MODIFICATION / SERVICE NOTE

Serial Numbers Affected: 1000 - 5400

Reason or Symptom: DC - DC Converter for display generates noise on Tx, Rx particularly in the 80 meter band.

T1 on Display unit

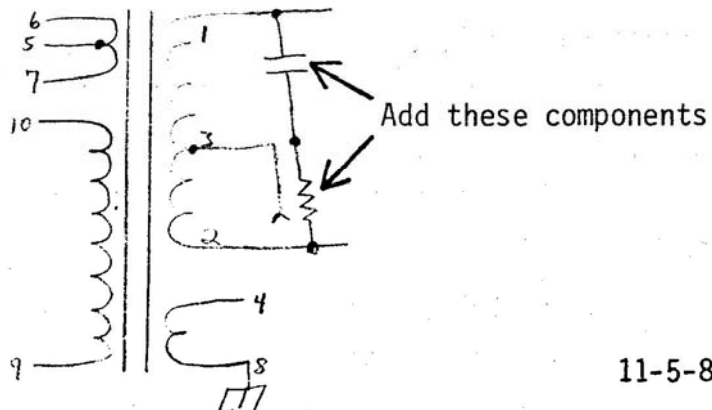
Unit	Ref #	Original	Replacement
Display	C26	0.001mFd	0.01/50V Mylar
"	C27	0.001mFd	22 ohm 1/4 watt

Procedure: Remove the display unit and locate C26 and C27 on the bottom side of the PC board. Replace components as listed above. NOTE: Earlier models may not have C26 and C27 installed, however, the new cap and resistor should be installed.
